LOT 11, BLOCK 5 UNIT 22, VOLCANO CLIFFS

DAVID SOULE P.E. #14522 IO CLIFFS SUBDIVISION

AGE PLAN

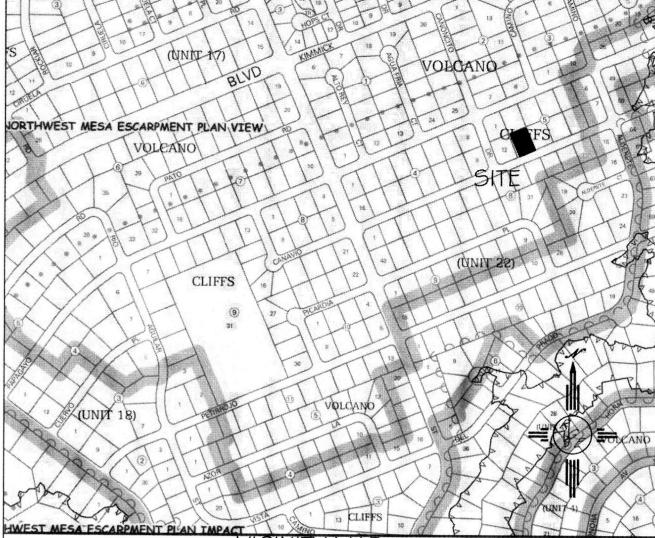
EXCEPTIONS: HOUSE PLAN WAS MIRROR IMMAGED, ONSITE

WATER QUALITY VOLME MET

LOT 3, BLOCK 5 RETENTION POND VOLCANO CLIFFS UNIT 22 485 cf - ok for first TOP=5325.35 BOTTOM=5324.00 VOLUME 1185 CF LOT 2, BLOCK 5 VOLCANO CLIFFS UNIT 22 LOT 1, BLOCK 5 **VOLCANO CLIFFS UNIT 22** TURN 2 BLOCK AT ELEVATION 5325.35 V EL=5326.31 NAVD 1988 PROVIDED BY CONSTRUCTION SURVEY LOT 10, BLOCK 5 PLS 21082 VOLCANO CLIFFS UNIT 22 TURN ONE BLOCK @ GRADE pipe@26.75 | **RETENTION POND** TO ALLOW FOR CROSS LOT DRAINAGE V BOTTOM=5326.00 3 TOTAL VOLUME 213 CF LOT 12, BLOCK 5 VOLCANO CLIFFS UNIT 22 RETENTION POND
TOP=5326.50
BOTTOM=5326.00
VOLUME 213 CF top=26.50 bottom=26.00 volume=220 cf
